**73, 75, 77 and 79 Keewatin Avenue and 88 Erskine Avenue – Site Plan Application – Request for Direction Report**

<b>Date:</b>	March 21, 2014
<b>To:</b>	North York Community Council
<b>From:</b>	Director, Community Planning, North York District
<b>Wards:</b>	Ward 25 – Don Valley West
<b>Reference Number:</b>	10 319752 NNY 25 SA

**SUMMARY**

Attachment 1: Landscape Concept Plan

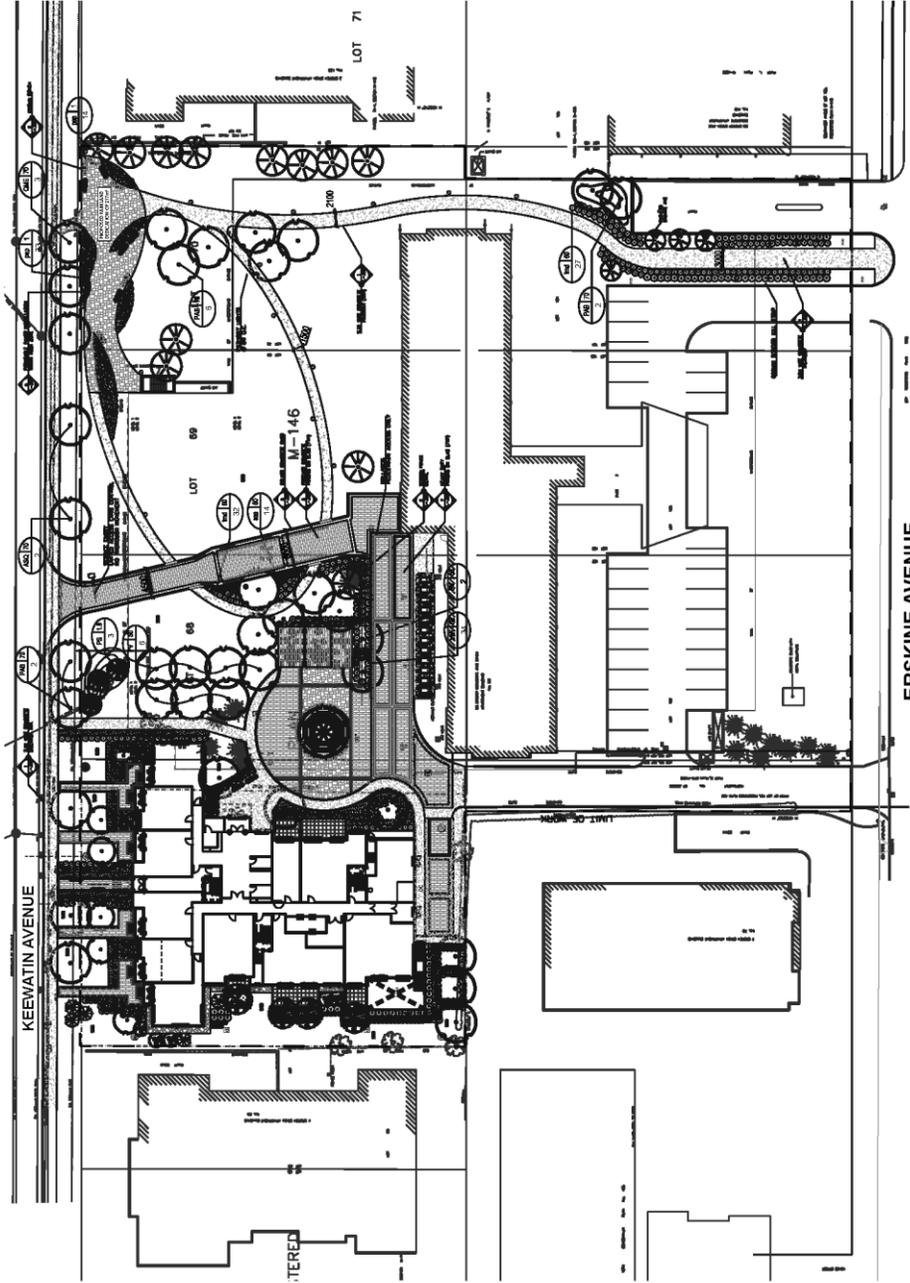
The improvements identified in the attached Landscape Concept Plan (Attachment 1) provide an opportunity for this issue to be addressed. The Landscape Concept Plan includes the removal of one pedestrian walkway and a new circular walkway that increases usable landscaped open space and provides space for increased landscaping and screening. The walkways in the Landscape Concept Plan integrate and connect together the new building, the new park, the public mid-block walkway, and Keewatin Avenue and Erskine Avenue sidewalks. The landscape concept includes shrub screening of the

proposed parking area as well as a new screen fence on the north side of the loading area. Shrubs and trees screen the north side of the loading area, while allowing views into and from the landscaped open space area to help address potential security issues.

The Concept Plan retains the driveway access onto Keewatin Avenue. The reconstructed driveway is to include an access control at the Keewatin Avenue frontage. This is to restrict the driveway function to only be accessed one way and from Keewatin Avenue and also to limit its use to large moving vans. Parking and through vehicle movements to Erskine Avenue are not to be permitted on the driveway. The final width of the driveway is to be no more than necessary for this function and is to include enhanced concrete pavers and rollover curbs that integrate it with the pedestrian walkway in the landscaped open space. Final landscape details will be secured as part of the detailed site plan approval.

A landscaped mid-block pedestrian connection is shown on the Concept Plan. This walkway is to include a landscaped area, lighting and a minimum 2.5 metre wide hard landscaped surface from Erskine Avenue sidewalk to the new park adjacent to the Keewatin Avenue sidewalk. The 9 surface parking spaces located at the south end of the proposed walkway and between the Erskine Avenue driveway and ramp to the underground garage have been removed. Removal of these parking spaces enables the final Site Plan and landscape plan to provide a publicly accessible pedestrian walkway connection with appropriate width and associated landscaping. Site Plan approval conditions will also secure a surface easement for public access to this landscaped and lighted midblock pedestrian walkway area, while allowing the owner to continue to address security concerns.

The proposed Site Plan addresses this issue by retaining and incorporating this tree into the landscape plan and by taking additional structural measures on the adjacent loading area pavement.
